AGENDA ELLETTSVILLE PLAN COMMISSION Zoom Meeting Thursday, March 4, 2021 - 6:00 P.M.

PC 21-06 – Preliminary Plat Staff Report

PC 21-07- Preliminary/Final Plat Staff Report

PC 21-02 – Preliminary Plat Staff Report

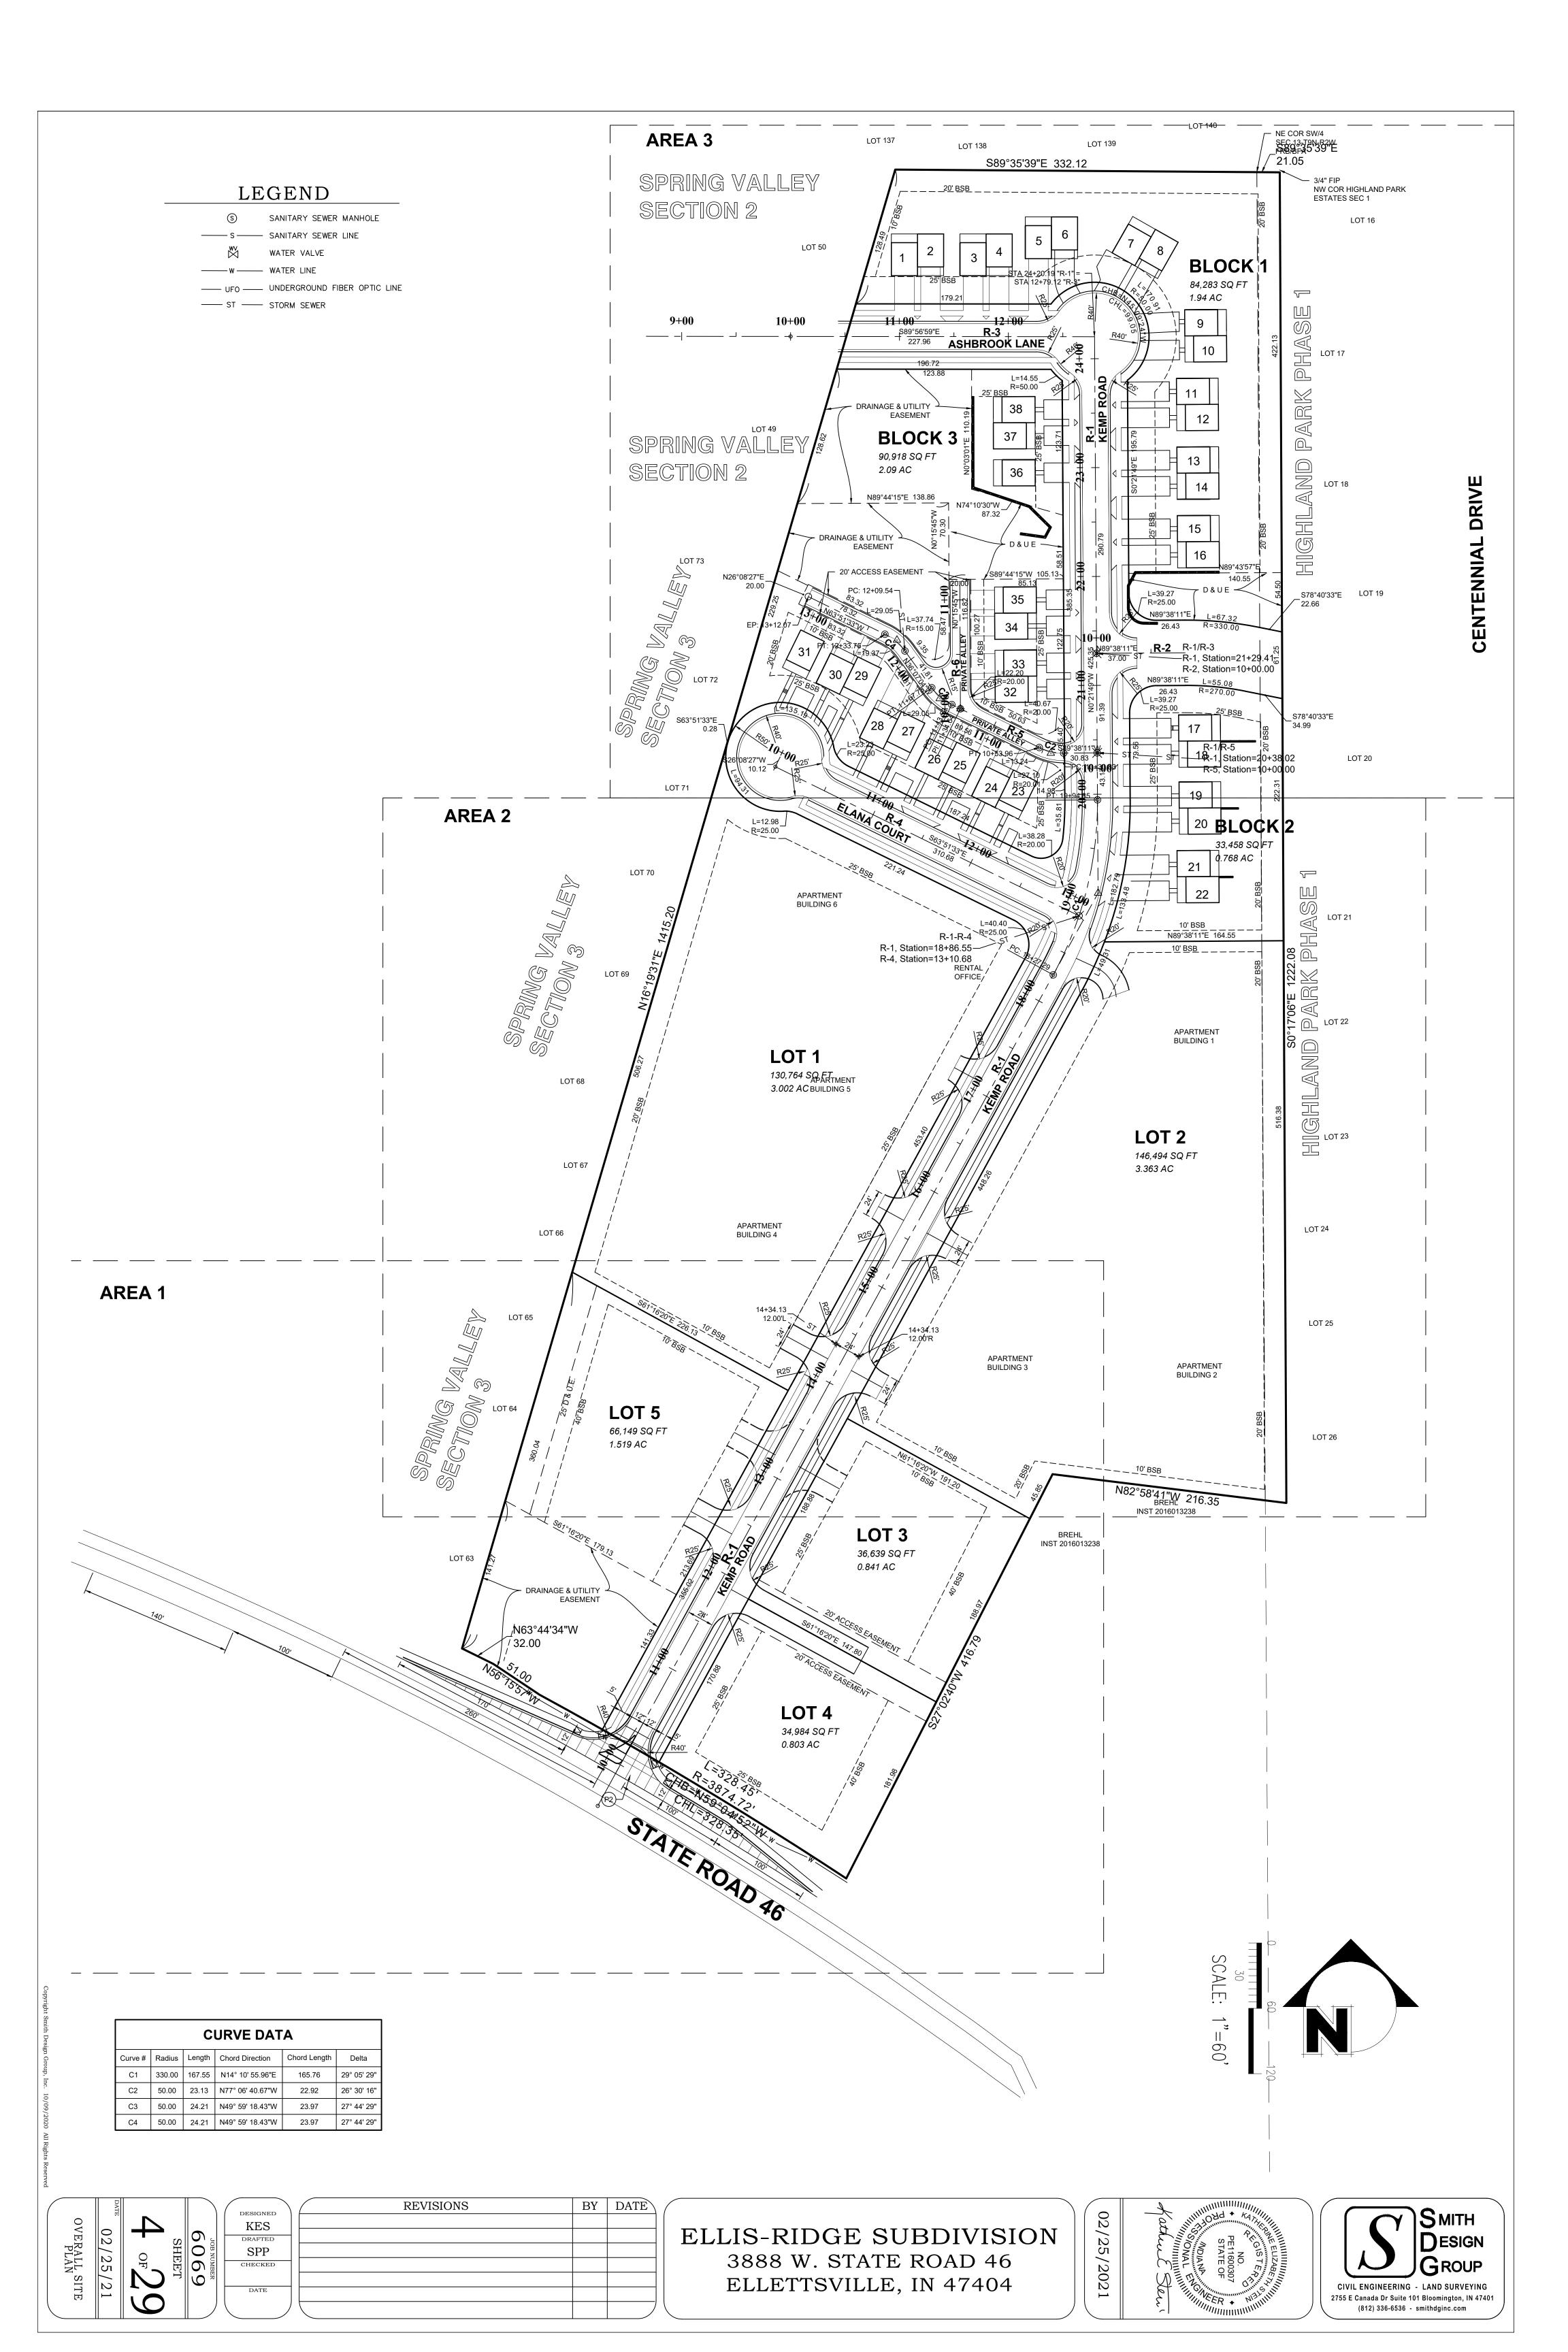
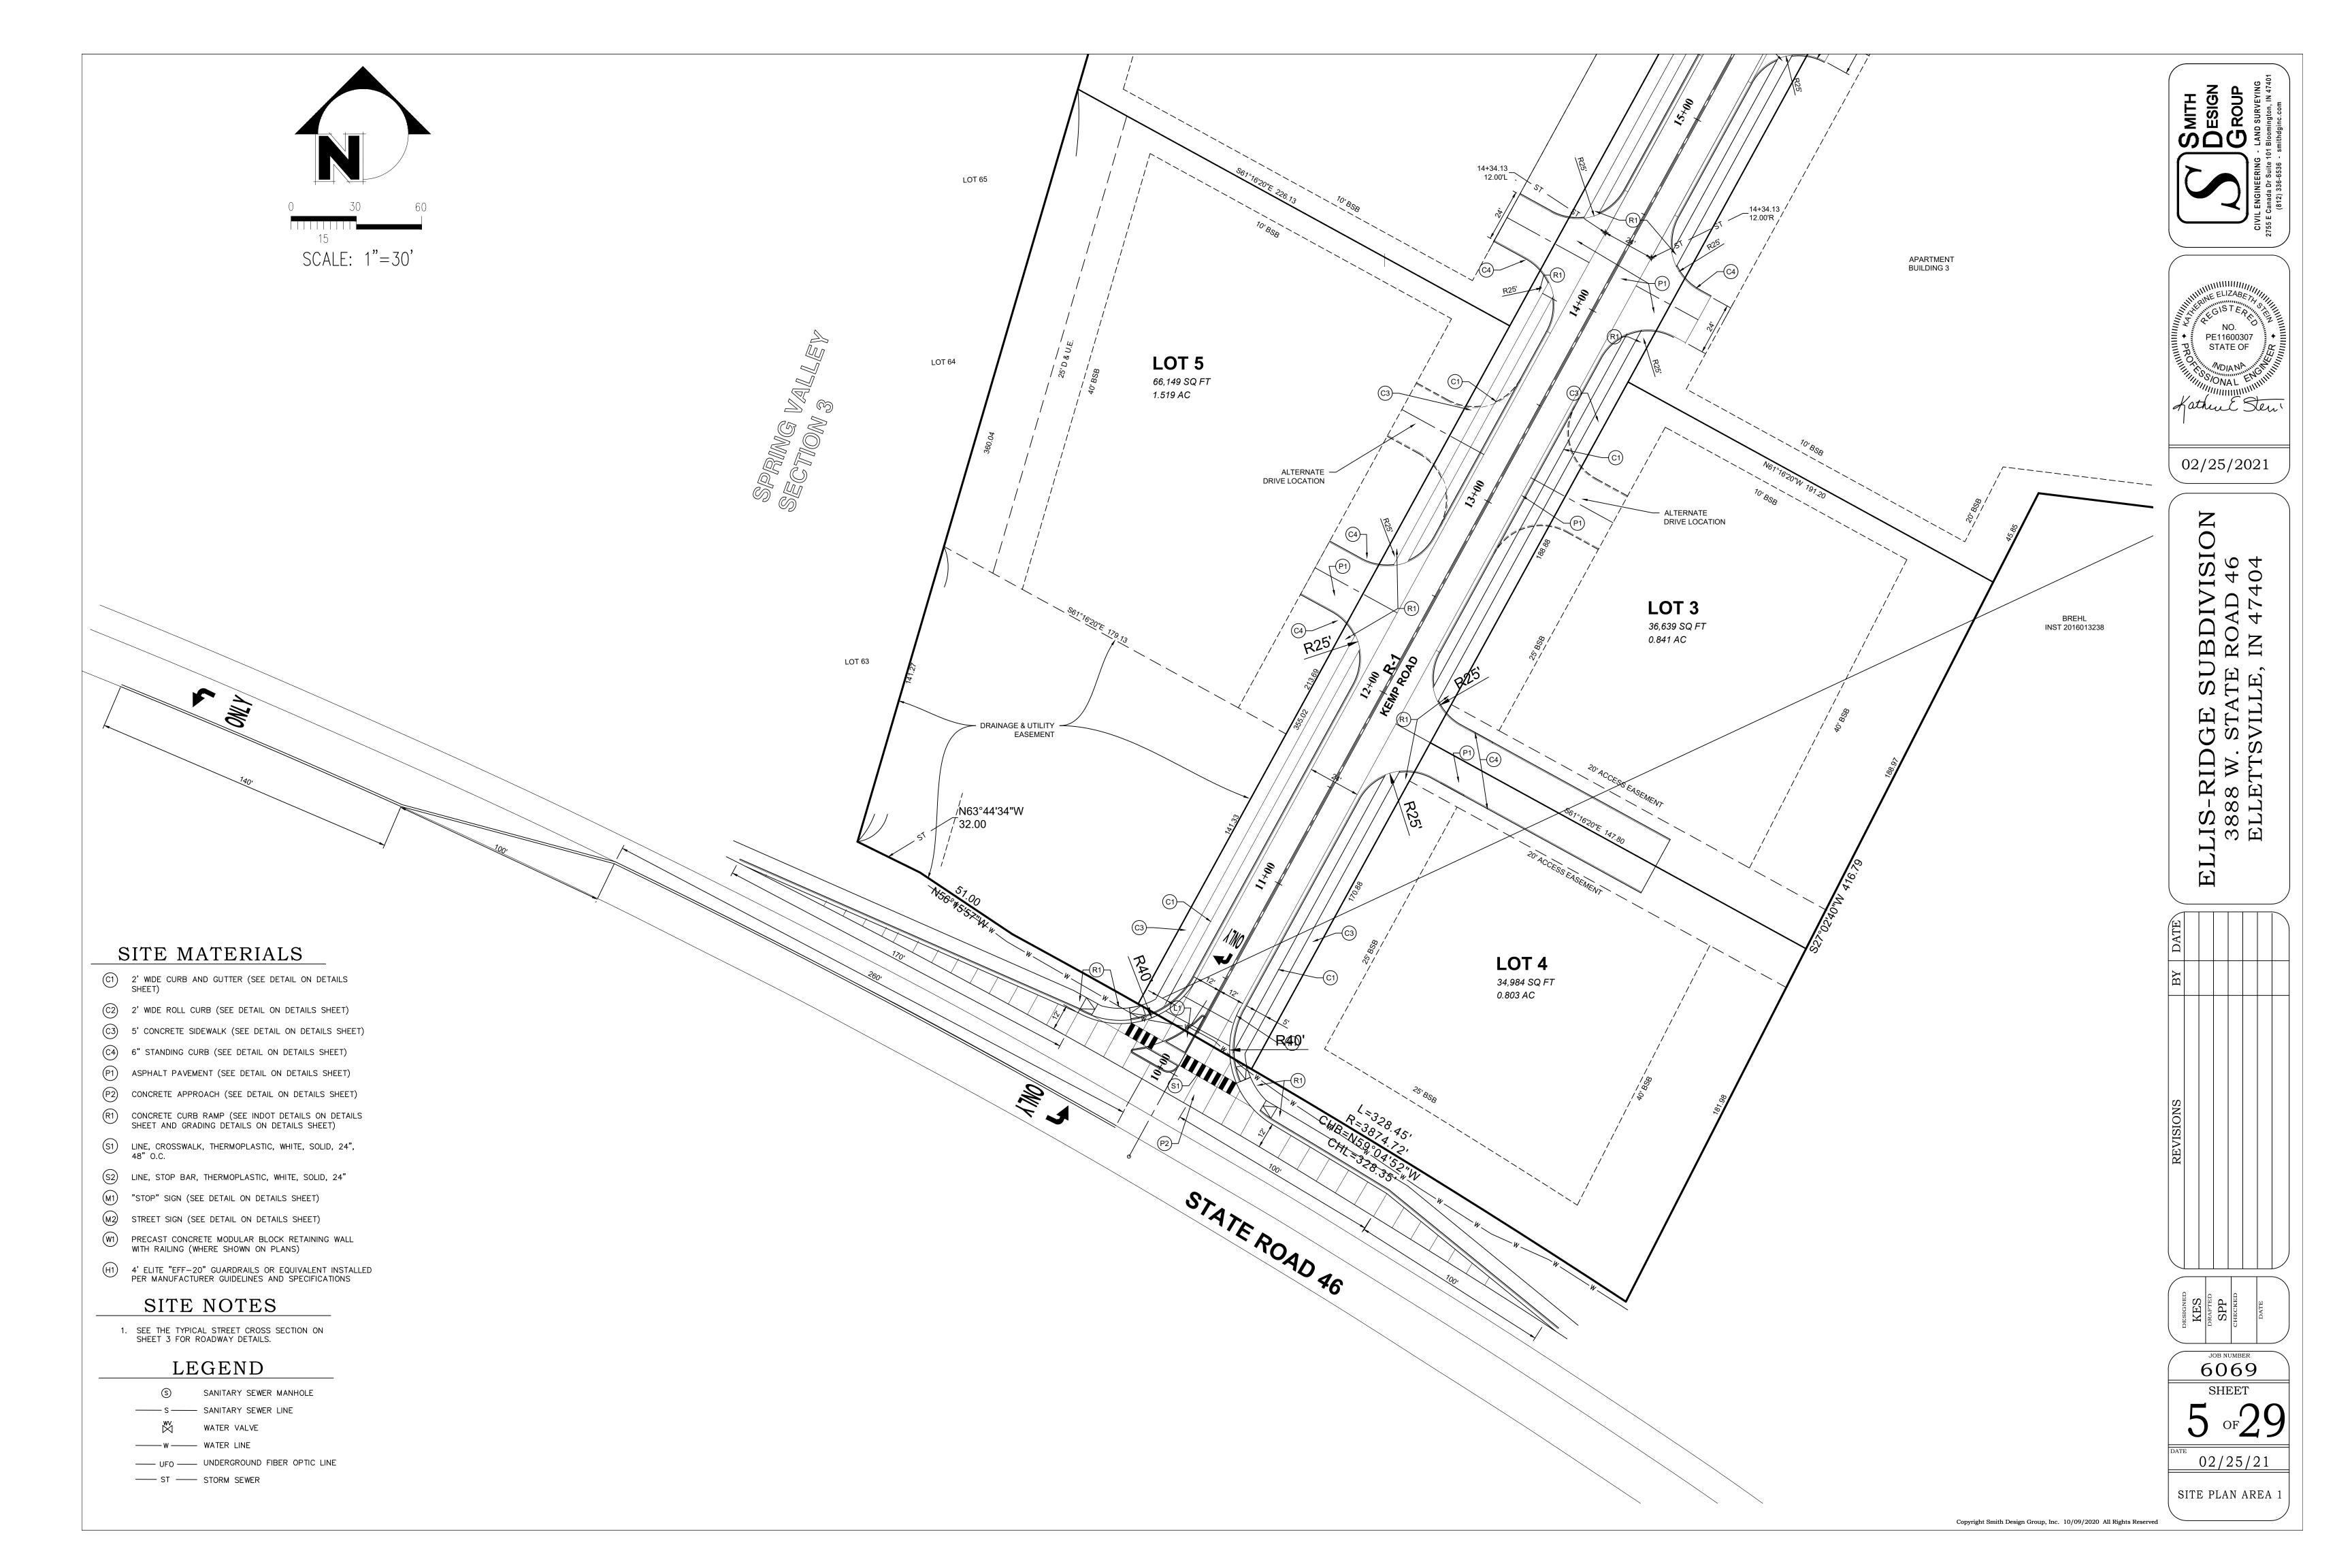
1. A landscape plan will need to reviewed prior to the Plan Commission meeting.

- 2. Street names will need to be provided for the cul-de-sac and the road connecting Ashbrook and SR 46.
 - a. Ellis Court cannot be used as there is already an Ellis Road in Monroe County.
- 3. All paired patio homes shall have a minimum of four (4) dedicated parking spaces.
 - a. This includes any spaces in a garage, driveway, or other dedicated off-street parking.
- 4. Alleys should remain as private roads.
- 5. Final plans shall be stamped by engineer.

- 1. Tracer wire should be used on all newly installed lines.
- 2. On page 24, the street sign detail shows in accordance with the City of Bloomington. Please change that to Town of Ellettsville (Town Ordinance 153.086)

- 1. Typical sections show the sidewalk dimension as 5 feet but there is a note referring to 4 feet.
- 2. An INDOT driveway permit will be required.
- 3. Setbacks should double when the commercial sections are adjacent to the residential zoning. The rear yard setback would be increased to 40 feet instead of the 25 feet as shown. (152.190)

- 4. The GIS aerial photography shows a pond on the property. The existing contours and development plan do not indicate a pond on the property. Removal of the pond should be approved by the appropriate governmental agencies.

- 7. Please provide detail of the retaining walls.
- 8. The detention pond underdrains should be shown on the grading and drainage plans.
- 9. The sanitary sewer will be reviewed by the Eastern Richland Sewer Corporation.

- 10. Drainage calculations will need to be submitted. The detention pond in the southwest corner of the property is shown connecting to and existing structure from the Springs Valley subdivision. The existing structure has a 12-inch pipe and Str. 101 has an 18-inch outlet pipe connecting to that structure. In addition, the depth of the existing structure does not seem to be adequate to connect to Str. 101.
